RESIDENTIAL COMMUNITY ZONING PLAN

APPLICANT	Cak Hall Companies, LLC	PETITION NO:	Z-56
	EMAIL:		09-07-17
REPRESEN'	TATIVE: Parks F. Huff	HEARING DATE (BOC):	09-19-17
	770) 422-7016 EMAIL: phuff@slhb-law.com		R-30
TITLEHOL	DER: Audrey Mae Wigley, By Gloria Wigley as		
Administrator	for the Estate of Audrey Wigley	PROPOSED ZONING:	R-15
PROPERTY	LOCATION: East and west sides of Wigley Road,		
north of Sumi	mitop Road	PROPOSED USE: Single-fa	amily Subdivisi
ACCESS TO	PROPERTY: Wigley Road	SIZE OF TRACT:	55.26 acres

APPLICANT: Oak Hall Companies, LLC	PETITION NO.:
PRESENT ZONING: R-30	PETITION FOR: R-15
********	* * * * * * * * * * * * * * * * * * * *
ZONING COMMENTS: Staff Member	er Responsible: Jason A. Campbell
Land Use Plan Recommendation: Very Low	v Density Residential (0-2 units per acre)
Proposed Number of Units: 85	Overall Density: 1.54 Units/Acre
Estimate could be higher or lower based on engineered patural features such as creeks, wetlands, etc., and other un	Units Increase of: 24 Units/Lots plans taking into account topography, shape of property, utilities, roadways, inforeseen circumstances.

STAFF RECOMMENDATIONS

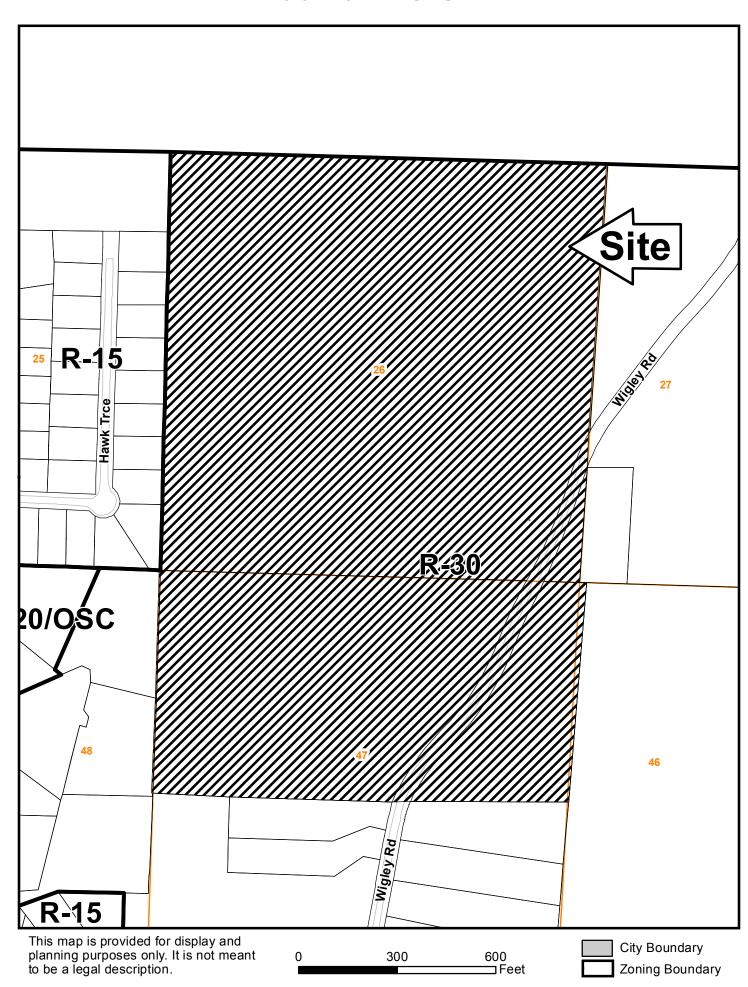
The proposed site plan will require the following contemporaneous variances:

- 1. Waive the front setback on all lots from the required 35 feet to 25 feet; and
- 2. Waive the public road frontage on cul-de-sac lots from 50 feet to 38 feet.

APPLICANT: Oak Hall Companies, LLC **PETITION NO.: <u>Z-56</u>** PRESENT ZONING: R-30 **PETITION FOR: R-15** STORMWATER MANAGEMENT COMMENTS - Continued SPECIAL SITE CONDITIONS Provide comprehensive hydrology/stormwater controls to include development of out parcels. Submit all proposed site improvements to Plan Review. Any **spring activity** uncovered must be addressed by a qualified geotechnical engineer (PE). Structural fill must be placed under the direction of a qualified registered Georgia geotechnical engineer (PE). Existing facility. Project must comply with the Water Quality requirements of the CWA-NPDES-NPS Permit and County Water Quality Ordinance. Water Quality/Quantity contributions of the existing lake/pond on site must be continued as baseline conditions into proposed project. Calculate and provide % impervious of project site. Revisit design; reduce pavement area to reduce runoff and pollution.

- 1. This site is located on the northern portion of Wigley Road. The site lies on a steep ridgeline and drains in three directions. The majority of the site (40%) drains to the south roughly parallel to Wigley Road. Approximately 35% of the site drains to the northeast along Wigley Road into Cherokee County. The remaining 25% of the site drains to the west into and through the adjacent Falcon Crest Subdivision. The site is predominately wooded with steep slopes ranging from 12 to 40%. The site layout needs to be sensitive to the steep topography. A preliminary rough grading plan should be provided to verify feasibility of the proposed layout.

- 2. Stormwater management for the site will be provided by multiple onsite detention ponds. The pond locations may need to be adjusted to limit grading required and to adequately control runoff from the development.

- 3. As indicated in the Downstream Conditions comments above, there is an existing lake located approximately 300 feet downstream. A pre- and post-development sediment study will be required to document any sediment impacts to this lake. Elevated onsite erosion control measures will be required due to the steepness of the site.

- 4. A downstream headwater pool analysis will be required for the existing receiving culvert in Falcon Crest S/D to verify no adverse impact. The basement at 2254 Hawk Trace is located significantly below the low point of the road.

Wigley Drive is classified as a local and according to the available information the existing right-of-way does not meet the minimum requirements for this classification.

Recommend curb and gutter along both sides and sidewalk along one side of proposed development roadway.

The existing Wigley Road right-of-way will need to be abandoned prior to Land Disturbance Permit.

- A. It is Staff's opinion that the applicant's rezoning proposal may not permit a use that is suitable in view of the use and development of adjacent and nearby properties. Almost all of the properties on this part of Wigley Road are zoned R-30 (only a portion of this part of Wigley Road is not zoned R-30). R-30 OSC would be a better choice due to the slopes.

- B. It is Staff's opinion that the applicant's rezoning proposal may have an adverse effect on the usability of adjacent or nearby property. The property is severely impacted by steep slopes and staff is concerned about erosion issues downstream and downslope. Other developments, zonings and densities in the area include: Jefferson Township Phase Five (zoned PD at approximately 0.32 units per acre); The Summit at Sweat Mountain (zoned R-30 at 0.72 units per acre); Bluffs at Jamerson (zoned R-20 at approximately 1.60 units per acre overall for Phases 1 and 2); Hampton Ridge Unit IV (zoned R-15 at 1.65 units per acre); and Falcon Crest Subdivision Unit III (zoned R-15 at approximately 2.50 units per acre).

- E. It is Staff's opinion that there are existing and changing conditions affecting the use and development of the property which give supporting grounds for denying the applicant's rezoning proposal. The surrounding area of Wigley Road is zoned as R-30. The steep slopes on the property, if developed in a more intense manner, can impact surrounding and downstream properties. Larger lot R-30 development would be preferable due to less grading activity. Staff is aware that other neighborhoods in this area have caused drainage and sedimentation problems due to smaller lot sizes on steep slopes. Staff would be amenable to an R-30 OSC plan due the steep slopes and adjacent zoning districts.

Based on the above analysis, Staff recommends **DENIAL**.
